104.1 Overview

[Insert at end of 104.1]

104.4.3.6 PSE State Diagram

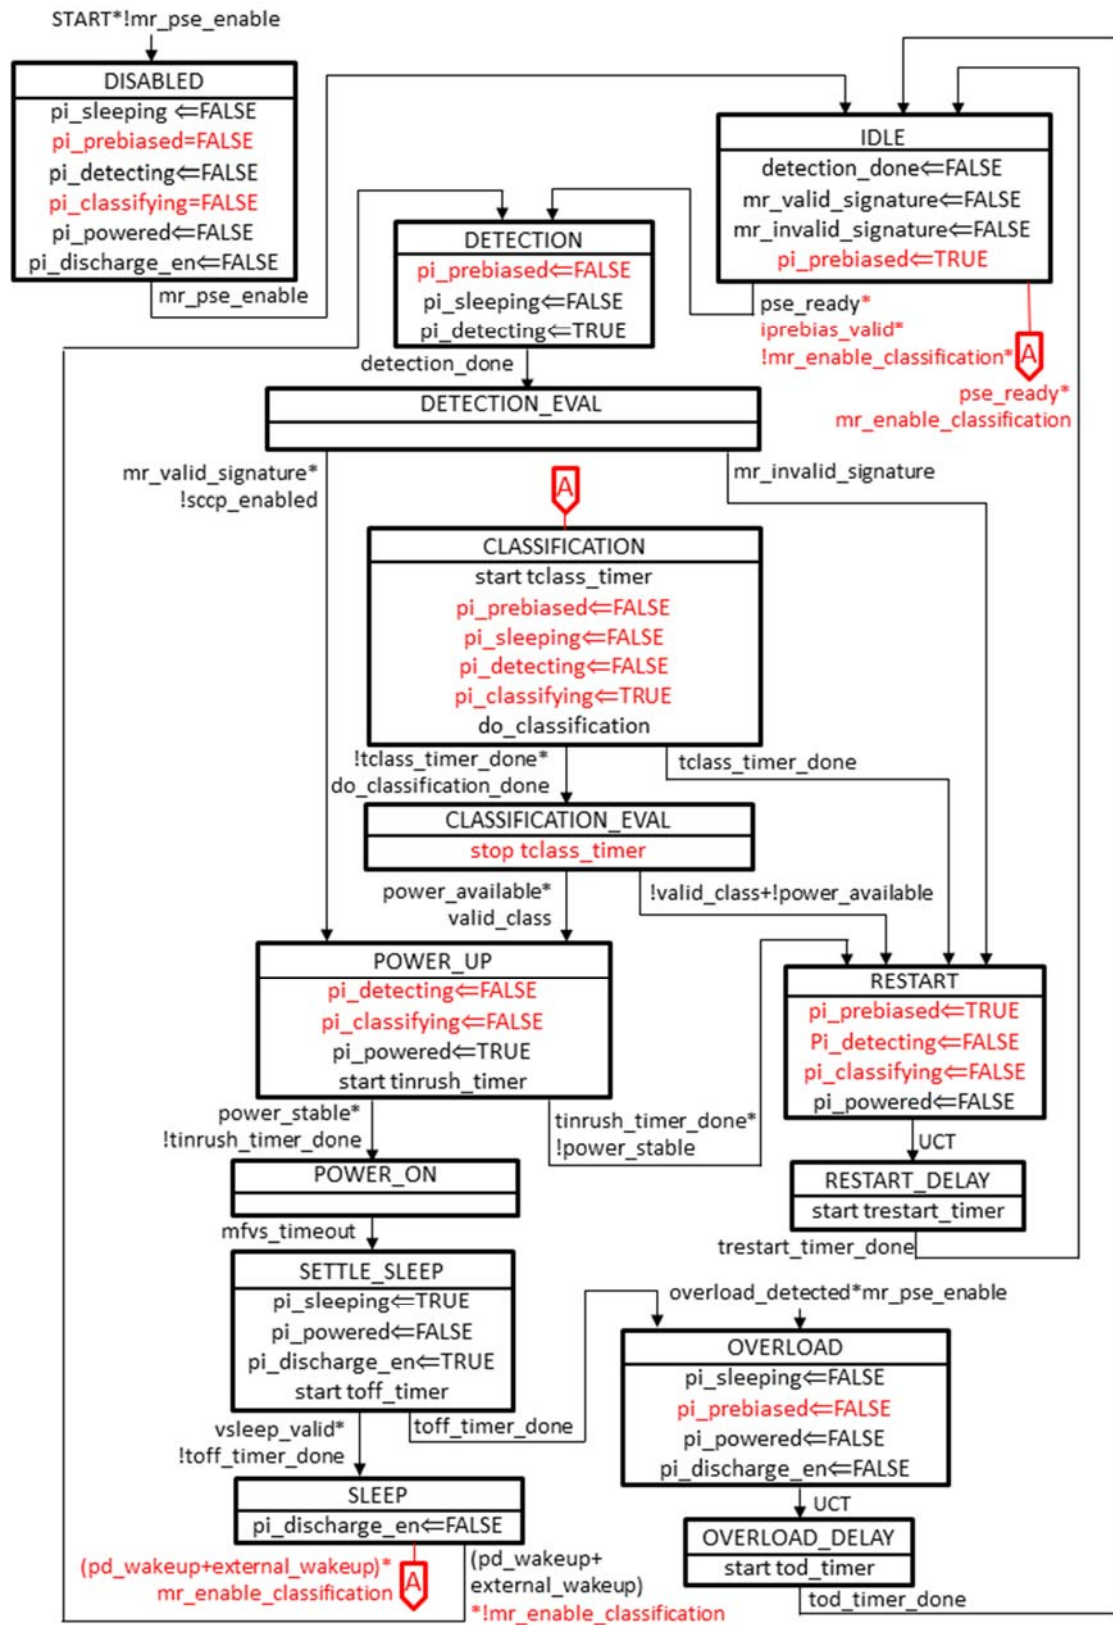
~~mr_sccp_enabled~~

~~TRUE: SCCP is enabled (see 104.7).~~

~~FALSE: SCCP is not enabled (see 104.7).~~

mr_enable_classification

TRUE: enable operation of the PSE do_classification function and disable detection

FALSE: disable operation of the PSE do_classification function and enable detection

104.5.3.6 State Diagram

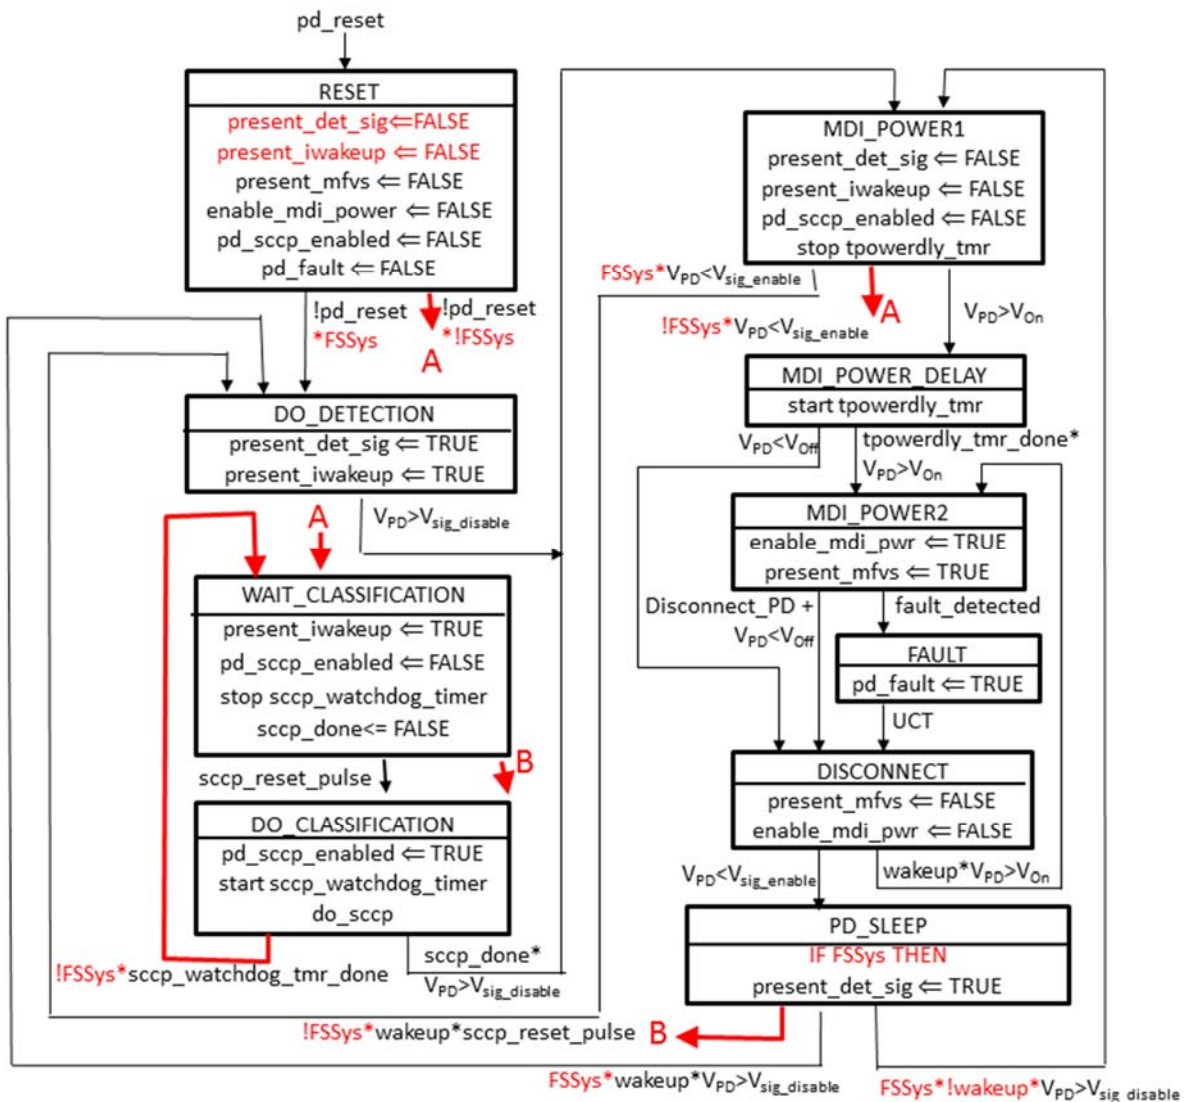
FSSys

TRUE: the PD is a FSS PD which implements detection but does not support classification

FALSE: the PD is a PPS PD which implements classification but does not support detection.

pd_sccp_enabled

TRUE: during ~~detection~~ WAIT_CLASSIFICATION or PD_SLEEP, a PSE reset pulse has been detected by the PD and a SCCP serial transaction is pending.

FALSE: during ~~detection~~ WAIT_CLASSIFICATION or PD_SLEEP, no PSE reset pulse has been detected by the PD.

sccp_reset_pulse

TRUE: during ~~detection~~ WAIT_CLASSIFICATION or PD_SLEEP, a SCCP reset pulse has been received by the PD.

FALSE: during ~~detection~~ WAIT_CLASSIFICATION or PD_SLEEP, a SCCP reset pulse has not been received by the PD.
